**ADA CURB RAMPS FY2014/2015 (STL405)  
ADA CURB RAMPS FY2016/2017 (STL415)  
AND  
REPLACEMENT OF CURB & GUTTER PROGRAM  
CITYWIDE FY2015/16 (STL407)**

**ADDENDUM #1**

This addendum is issued before the Bid Opening to inform the bidders of a date inconsistency, revised submittal requirements pertaining to Prevailing Wage Rates and to update the Bid Proposal. The following information is for Contractor use in developing bid packages:

**DRAWING NUMBER D-03A**

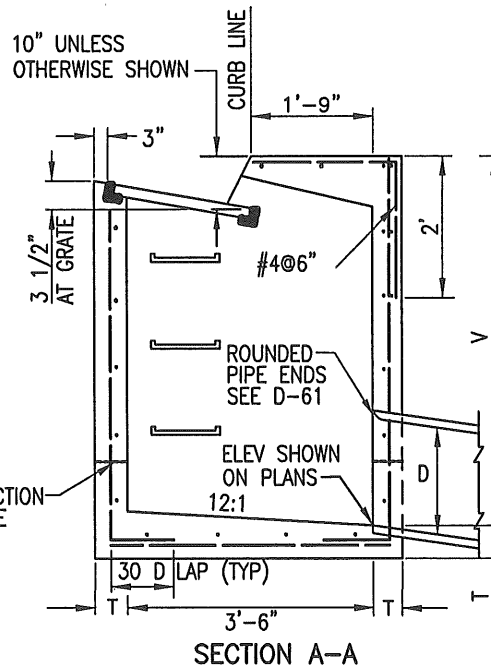
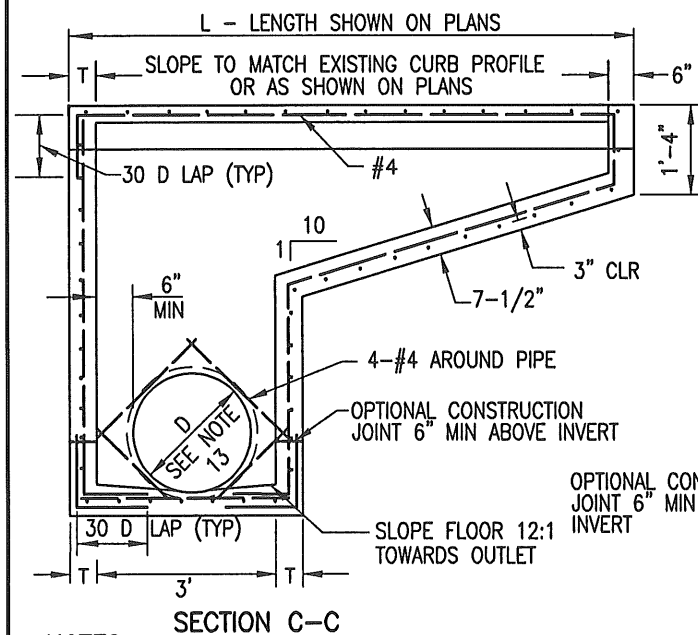
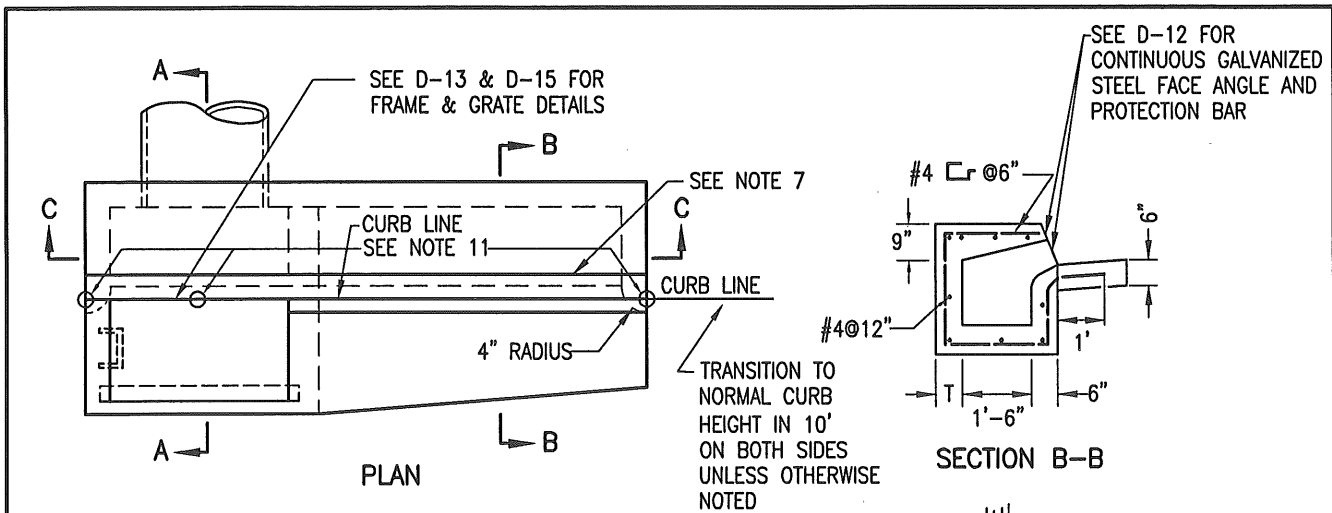
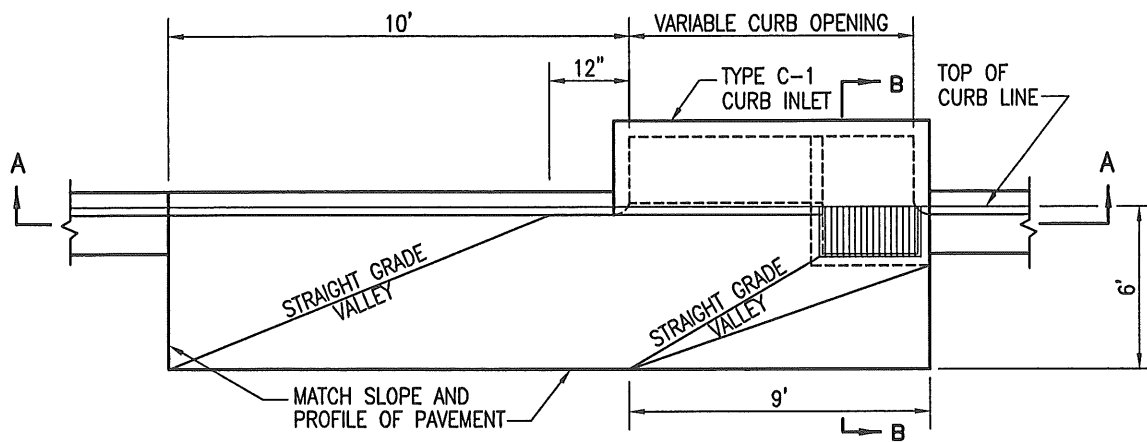
- 3. New Item of Work – Replacement of one curb inlet at the SW Corner of Hilltop Drive and Vista Way, (Ramp Location No. 110) – See Attached Bid Proposal.**

Add attached Standard Drawings to Appendix D.
